Memorandum

TO: Columbia River Crossing Task Force
FROM: CRC Pedestrian and Bicycle Advisory Committee (PBAC)
SUBJECT: PBAC Recommendations for World Class Pedestrian and Bicycle Facilities

Purpose of this Memorandum

PBAC Proposed Pedestrian and Bicycle System for Replacement Bridge

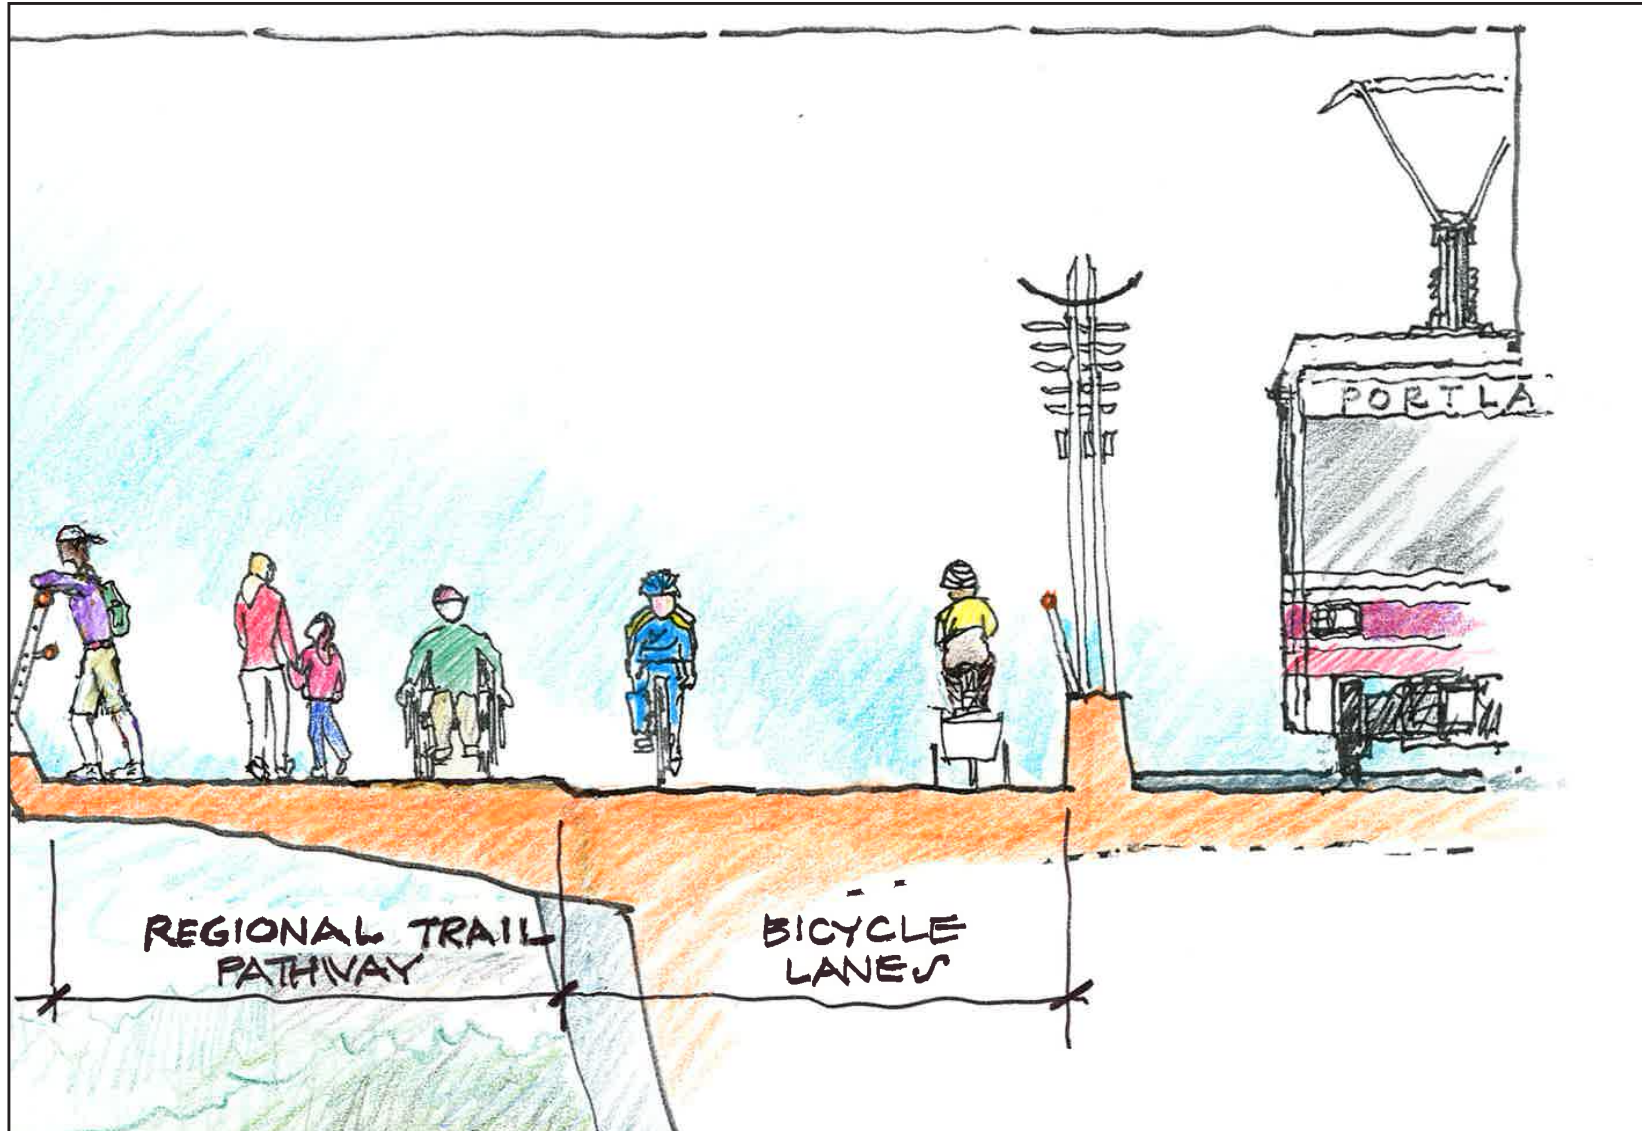
- The overall pathway on the western bridge (adjacent to the transit guideway) must provide separation between recreational users and higher speed bicycle users. To provide this separation, a 12-foot wide regional trail should be provided adjacent to, and to the west of, a pair of six-foot wide bicycle lanes (see attached rendering). These recommended widths are exclusive of potentially needed shy distances, i.e., free and clear of poles and other obstructions to enable safe pedestrian and bicycle movement (a summary of agency standards for multiuse paths, sidewalks and bike lanes is attached).

- In addition to the combined regional trail and bicycle lanes on the western bridge, an eight-foot wide sidewalk should be provided on the eastern bridge (the bridge that would serve the northbound traffic lanes) across both the Columbia River and the North Portland Harbor. The sidewalk across the North Portland Harbor would touch down on Hayden Island and use surface street sidewalks to connect to the sidewalk across the Columbia River.
